CITY OF PORT WENTWORTH

PLANNING COMMISSION

MAY 10, 2021

Re: Site Development Plan
Home 2 Suites TDB Magellan Boulevard
Port Wentworth, Georgia

SHEET
6 OF 25

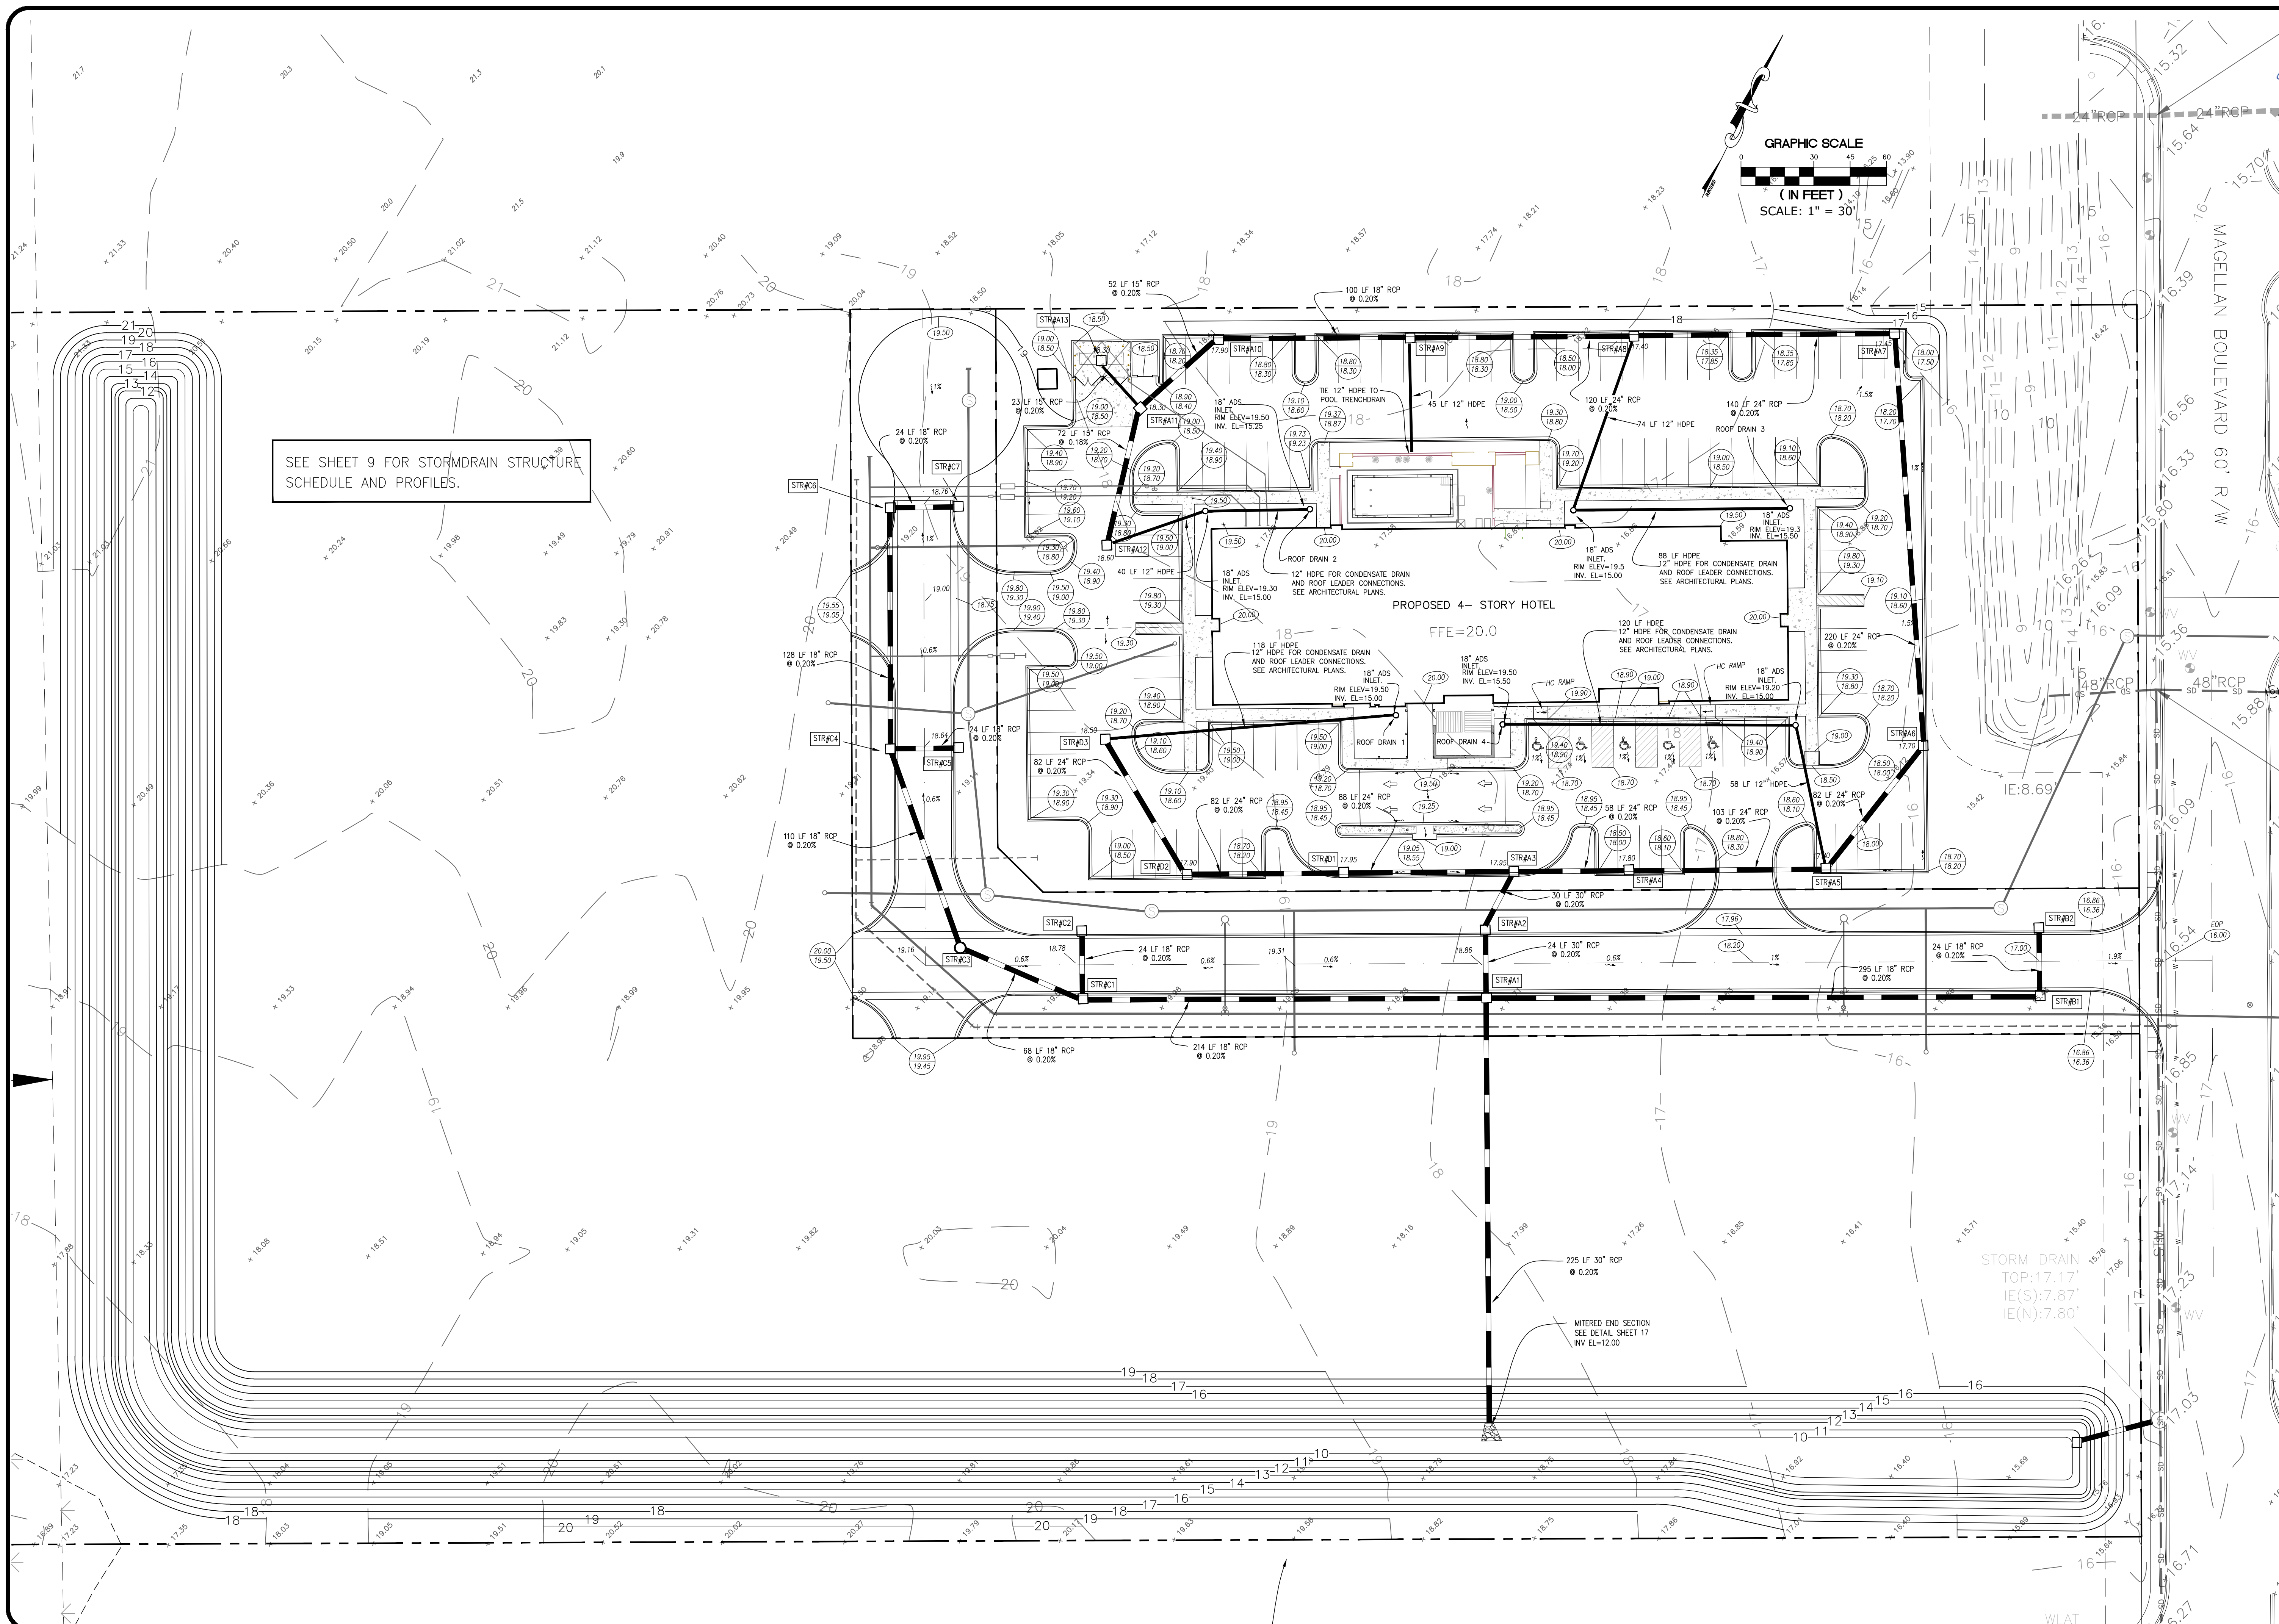
16. On sheet 6, Drainage Plan, the pond outlet control structure and outlet pipe are not identified. The drawing does not identify the type of connection to the existing system.

17. On sheet 6, Drainage Plan, the outfall to the pond shows a mitered end section and to see detail on sheet 17. There is not a detail on sheet 17, a detail is shown on sheet on sheet 20 but it is for a HDPE mitered end section. The City of Port Wentworth prefers concrete flared end sections for pipe ends. The detail SD-11 was provided on sheet 24 which is for flared end sections. Please update drawing with these changes.
